Field Service Action

FSA 25SE6

Final Repair - Safety Recall 25SE6

Certain 2022-2026 Model Year Transit and Transit / Tourneo Custom
12V AGM Battery Venting

Figure 3

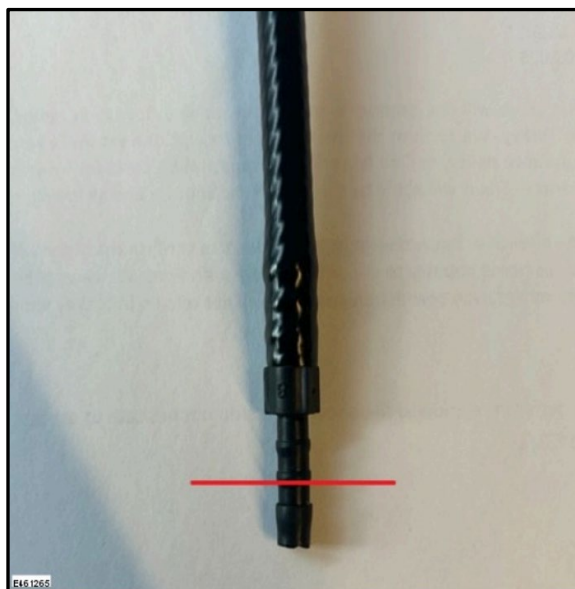
6. Install tube firmly in bottom hole of battery tray and reinstall the removed battery(s) in tray. Insert to the red line as in illustration. Figure 3.

7. Fit other side of tube to vent/s in the battery(s). Figure 3.
